# Update to bit-muxing constraints for 8:8 PMA (in support of comment 83)

P802.3df, Interim meeting, May 2023

# 802.3df D2.0 - Comment #83

# Recap - PAM4 Retimer (based on 802.3cw D2.0)

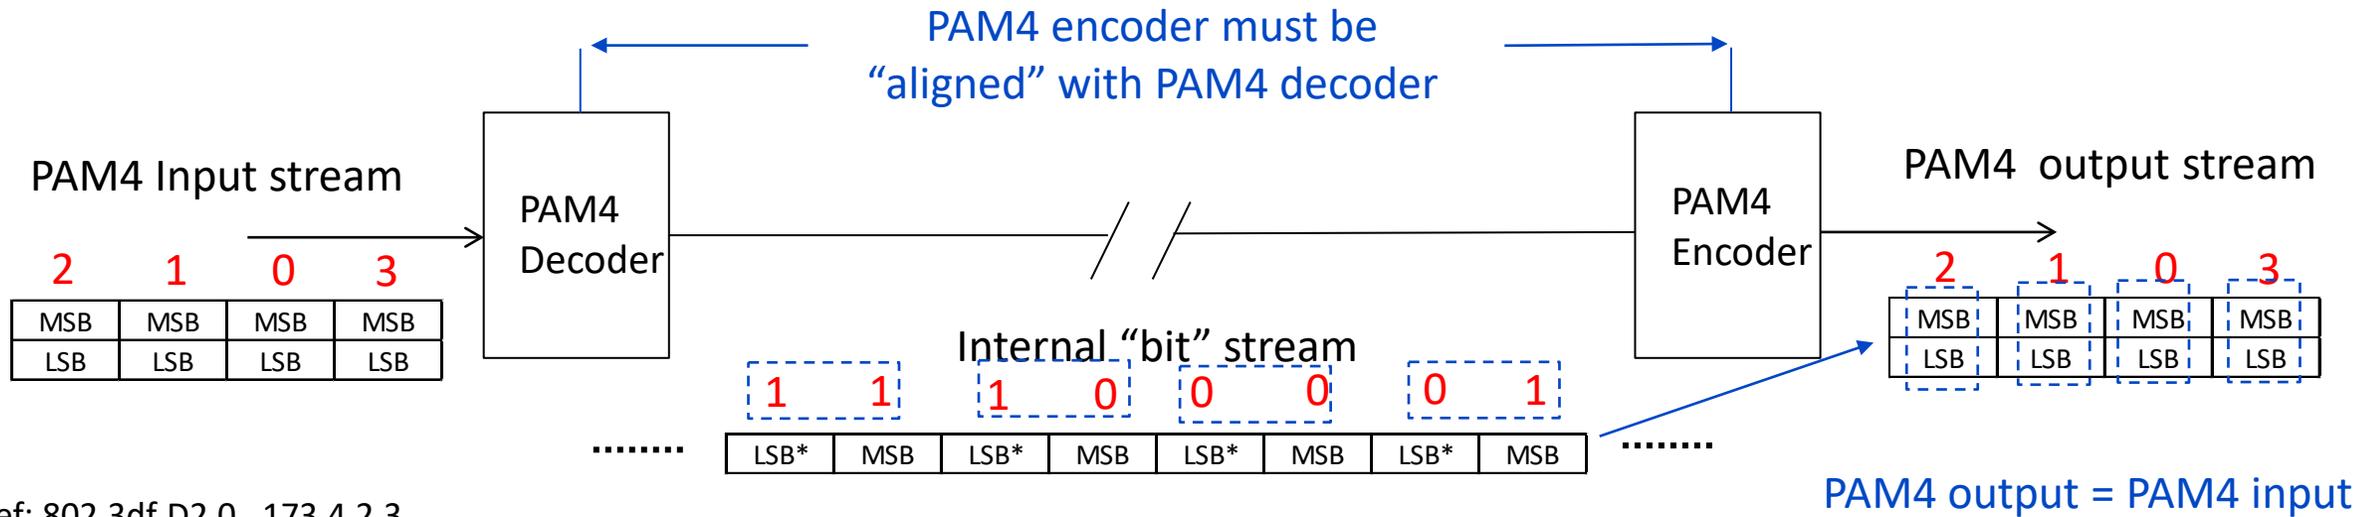
- PAM4 encoder must be PAM4 symbol aligned to the PAM4 decoder
  - how this alignment is achieved is an implementation choice (there are many possible options)
- PAM4 output symbol stream is always identical to the PAM4 input symbol stream (assuming no errors)
- But this forces an additional constraint which was not required for 400GbE PAM4 retimer chips
  - though it is possible many implementations work like this anyway ?

# Proposal - revert to “400GbE based approach” ...

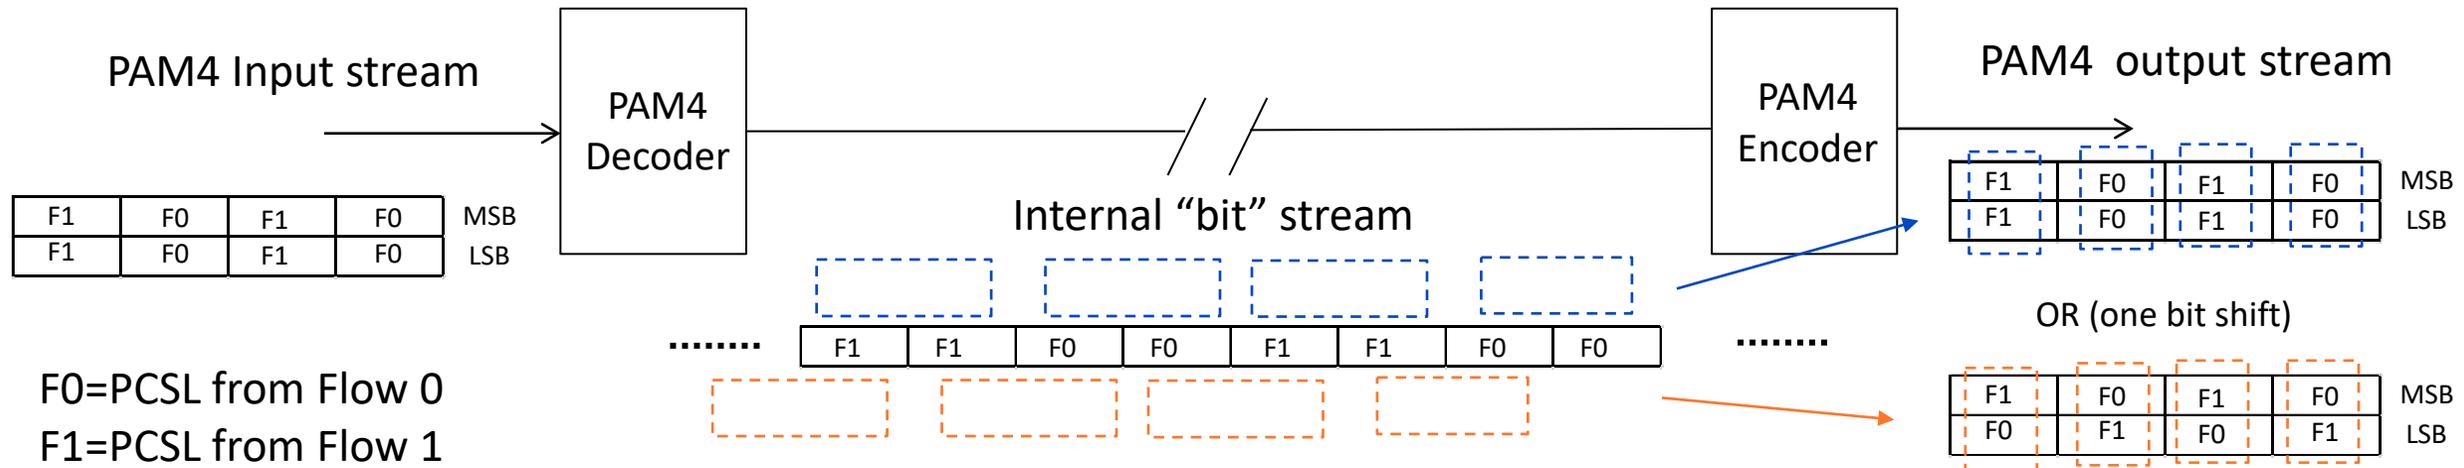
- Does not require the PAM4 encoder and PAM4 decoder to be “aligned”
  - thereby consistent with 802.3bs (400GbE) implementations based on Clause 120
- Allows a “one bit shift” between PAM4 encoder and PAM4 decoder
- Produces two possible PAM4 output streams for a given PAM4 input stream, but in both cases the LSB is split equally between the two flows (meeting the requirement of slide 3 of [ran\\_3df\\_01b\\_230130](#))

# Proposal - alternate PAM4 input (/w “one bit shift”)

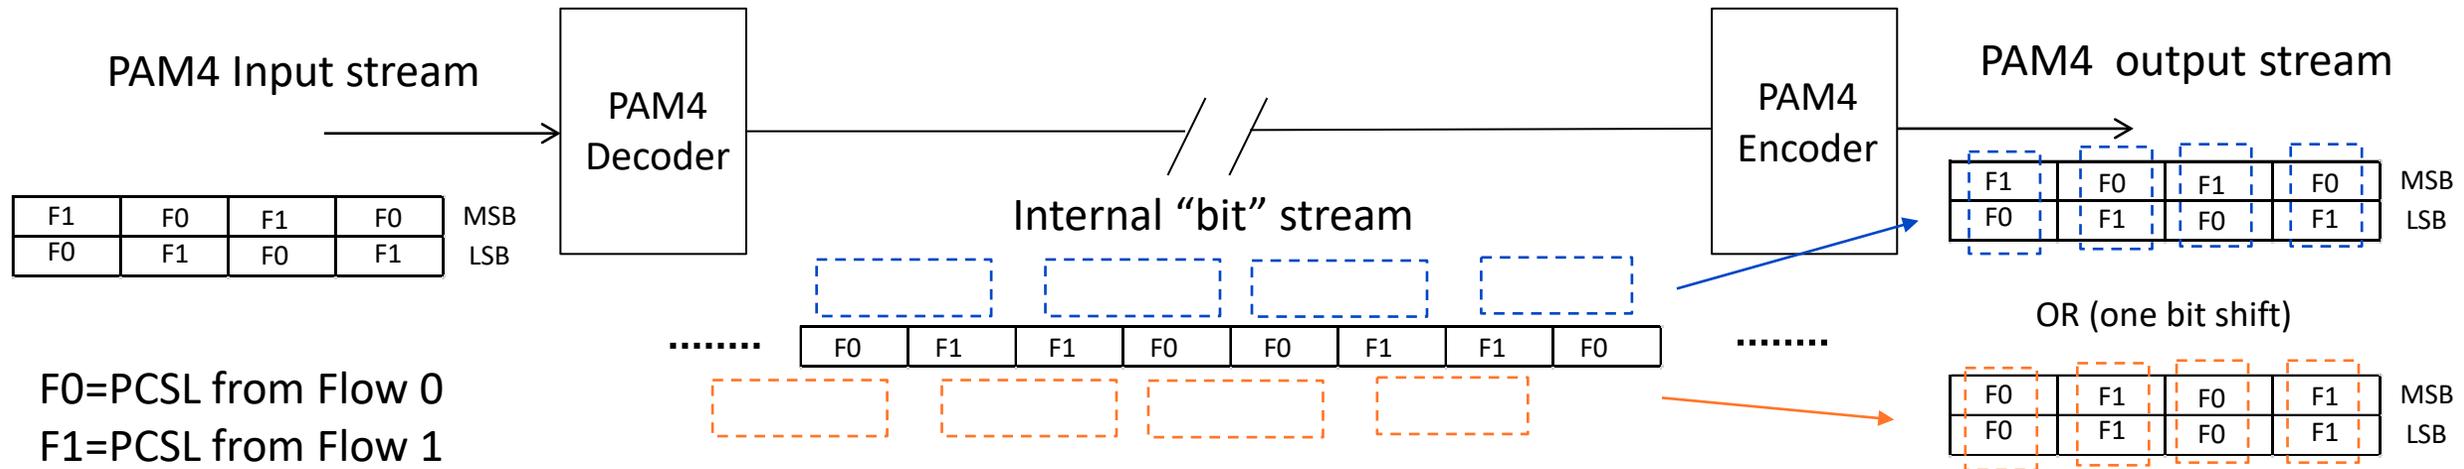
- Note, 802.3df D2.0 allows a “one bit shift” for the 32:8 PMA and 8:32 PMA, so it is possible to get the alternate PAM4 stream at the input to the retimer shown above
- In this case the two possible PAM4 output streams from the retimer are simply reversed from the ones shown on the previous slide
- This essentially means there is no value on the additional constraint on the 8:8PMA, as you can still get the same two possible PAM4 output streams anyway (as the 32:8 PMA and 8:32 PMA can both generate the same two options for the PAM4 stream)
